RE:
Harry & Webb Commercial

DRAINAGE PLAN

HARRY & WEBB

FINAL REPORT

DRAINAGE & GRADING PLAN
HARRY & WEBB COMMERCIAL

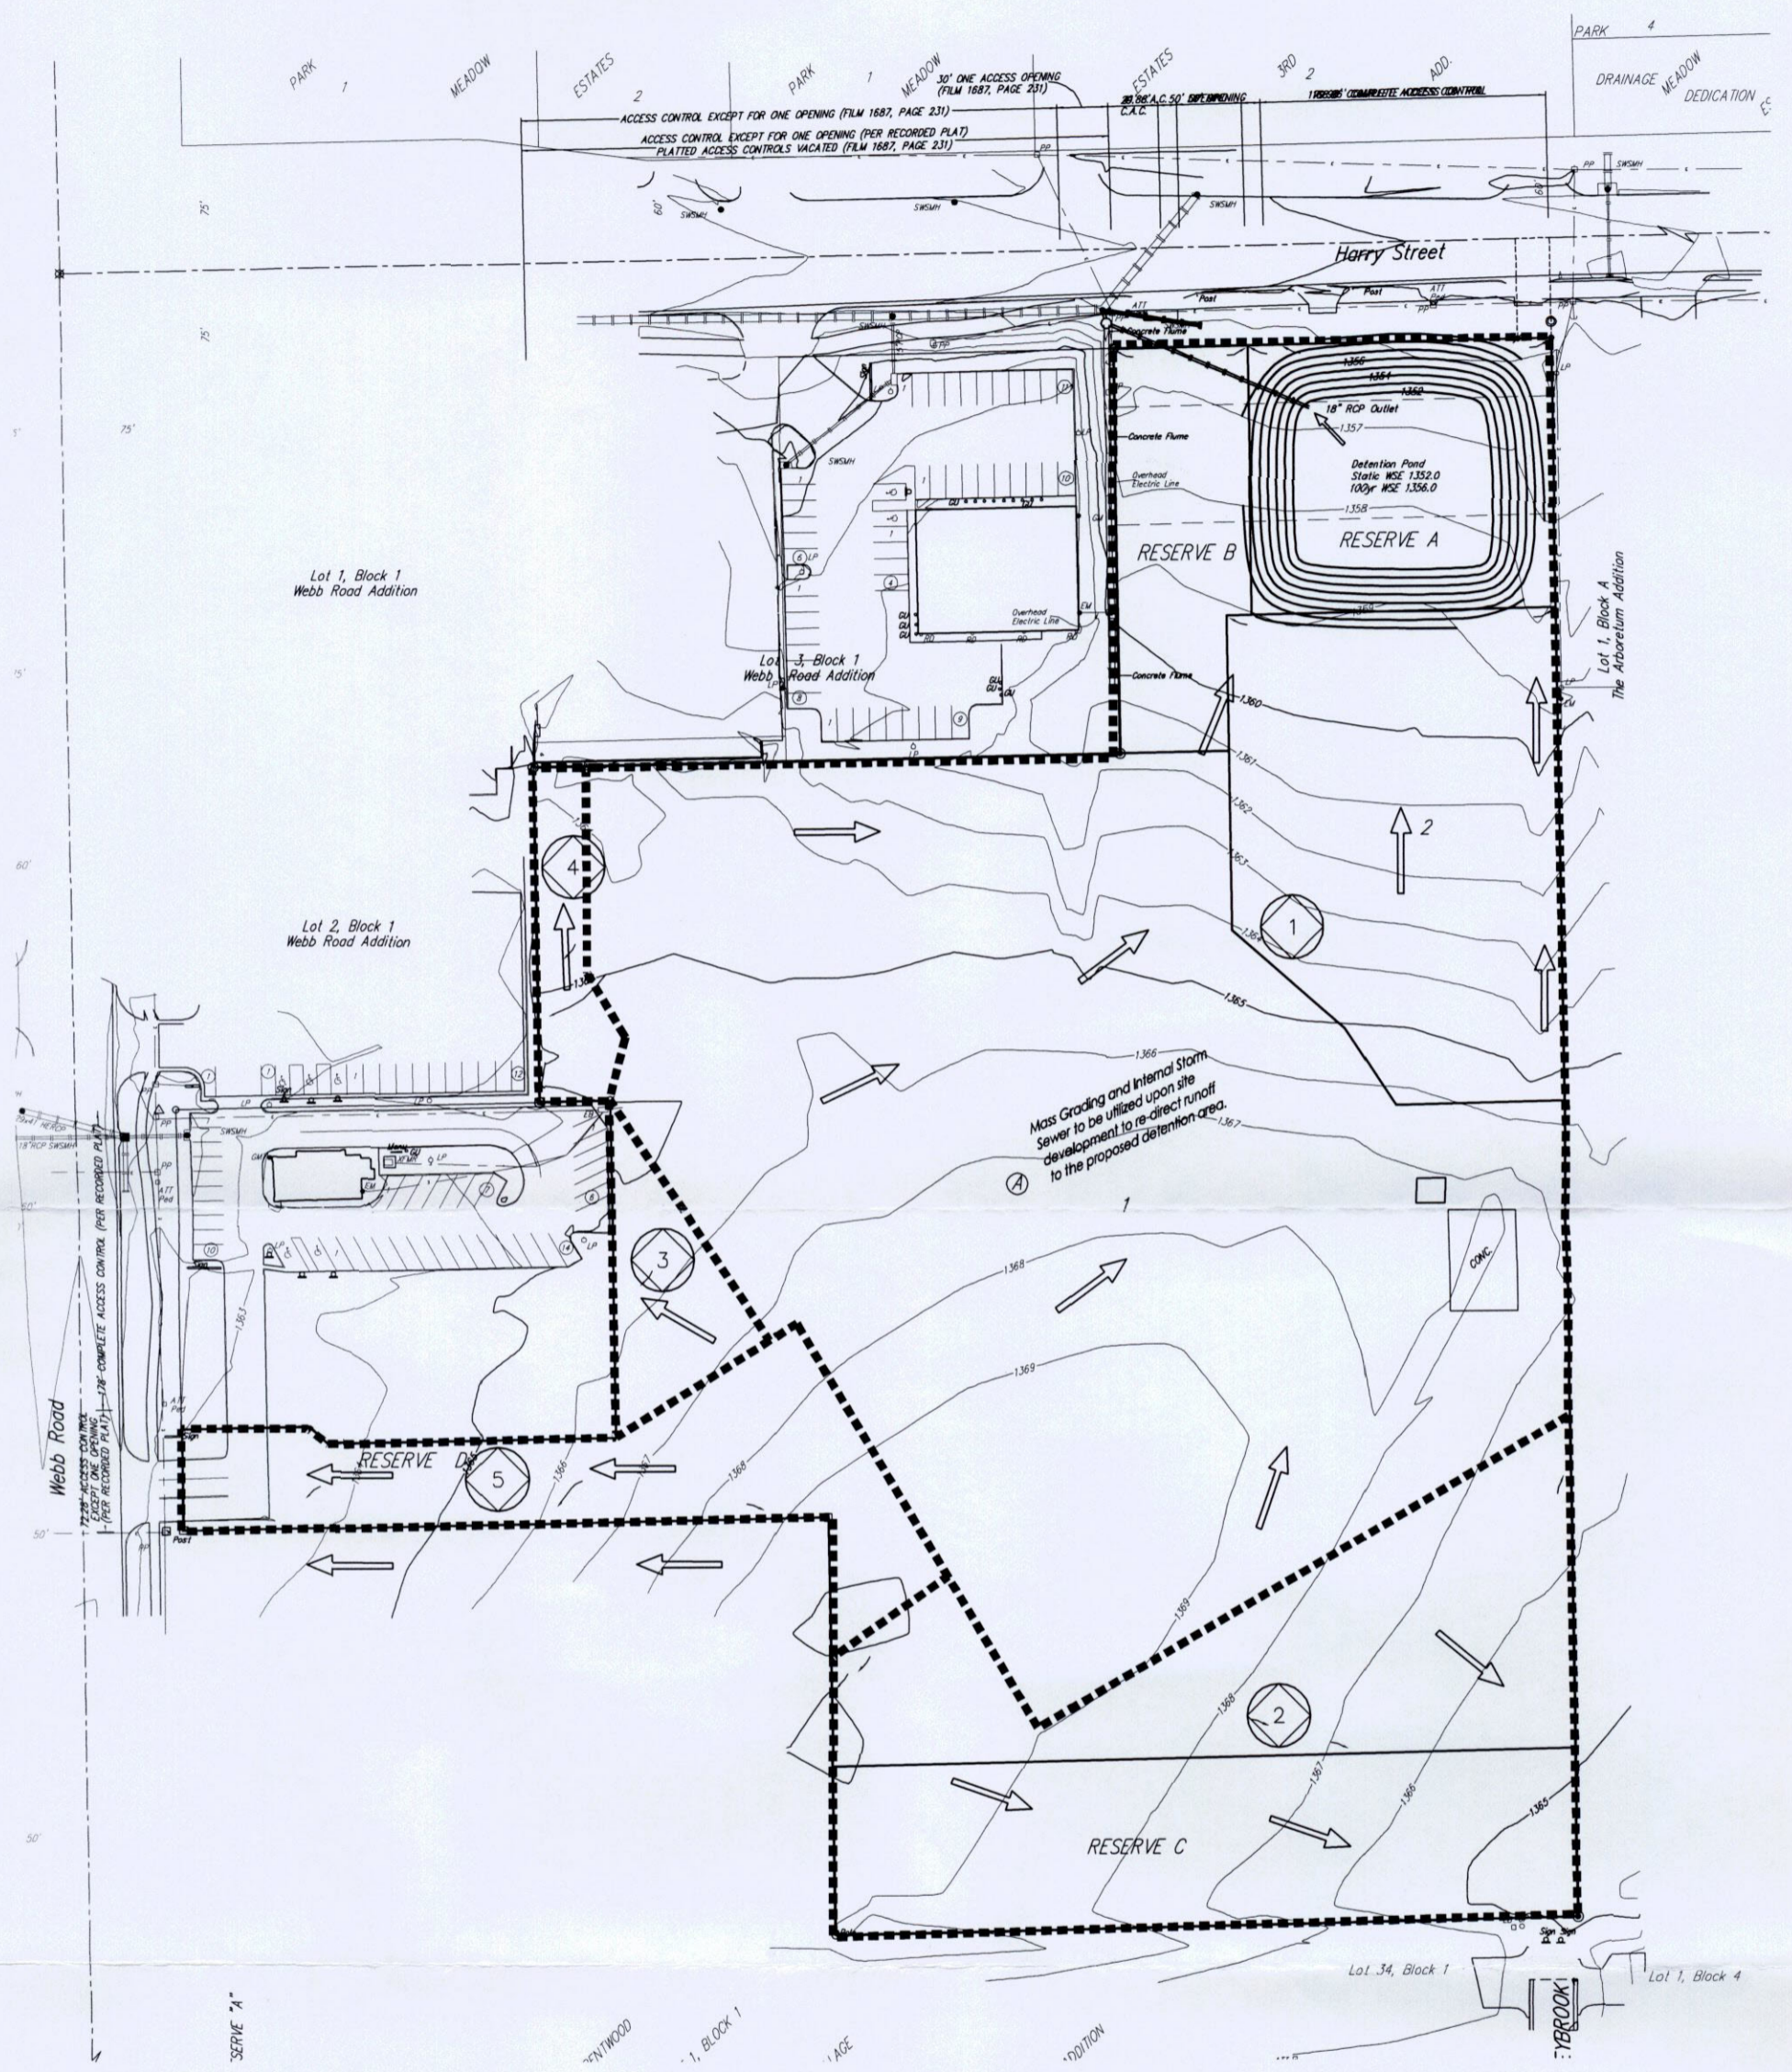
Can you more explicitly point out in the report that all of Basin 2, post-, is not developed? That clarity will make it easier to enforce the drainage plan/report in the future. You can infer all of Basin 2, post-, is undeveloped when you look at the curve number, but that is easy to miss. While looking at the drainage plan, we had the impression that the part outside of the reserve was going to be developed/paved, and it was not clear if the curve number for Basin 2, post-, was an oversight, or not.

Please include your best-guess break for Basin 5 with respect to the sump for the inlets and narrative on how that drains.

Post-Developed Conditions under the Discharge Points Summary.

Also, the CN is exactly the same as the existing CN for this area. Common sense will tell someone that it is un-developed based solely on the Proposed Plan sheet. The basin lines are very clear as is the CN – this area is undeveloped – whether in the Reserve or not. I tried to be as conservative as possible with high CNs for the rest of the site (98 for all of it – even with the open space left at the corners as you can see). I really don't see how this would not be enforceable. If someone deviates from the basin areas or the CNs – then they need to prove why and how they will take care of it. Seems really clear from where I am standing. When a site plan is officially submitted, you/Scott need to review it and make sure it matches the Drainage Plan. If it doesn't, then these questions/concerns can be dealt with more in-depth.
trk
